UNITED STATES PATENT AND TRADEMARK OFFICE

APPLICATION NO.	FILING DATE	FIRST NAMED INVENTOR	ATTORNEY DOCKET NO.	CONFIRMATION NO.
10/592,969	06/25/2008	Silvia Gerstner	2004P00358WOUS	4067

Office Action Summary	Application No. 10/592,969	Applicant(s) GERSTNER ET AL.	
	Examiner DAN ROHRHOFF	Art Unit 3637

DETAILED ACTION

Leimkuehler Fig. 4

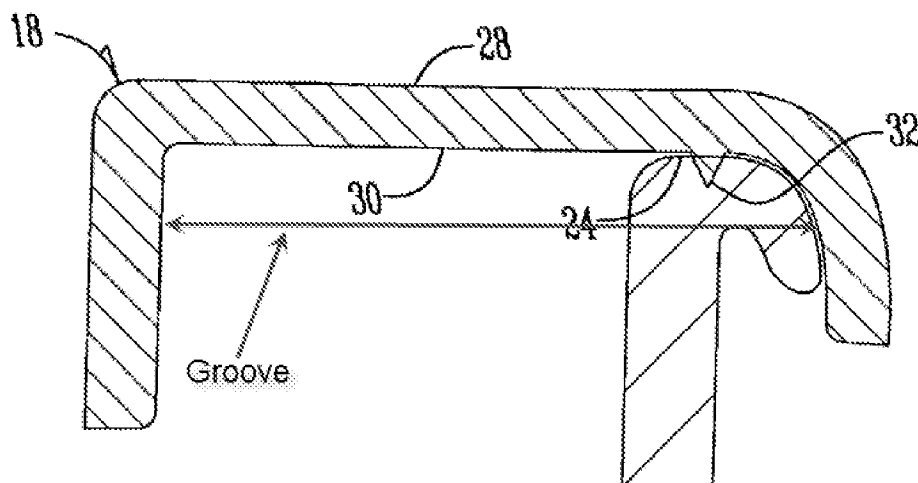
8. Regarding claim 11, Leimkuehler, as modified, teaches a refrigerator wherein the strip has a groove (see annotated Fig. 4) into which the edge of the compartment for accommodating articles to be cooled is inserted (Fig. 4).

9. Regarding claim 12, Leimkuehler, as modified, teaches a refrigerator wherein the depth direction of the groove is aligned transversely to the radius of curvature of the decorative strip (Fig. 4).

10. Regarding claim 13, Leimkuehler, as modified, teaches a refrigerator wherein the width of the groove increases, at least at certain points, from an inlet region of the groove to its bottom (Fig. 4 shows the width of the groove to increase from the top (inlet region) to its bottom).
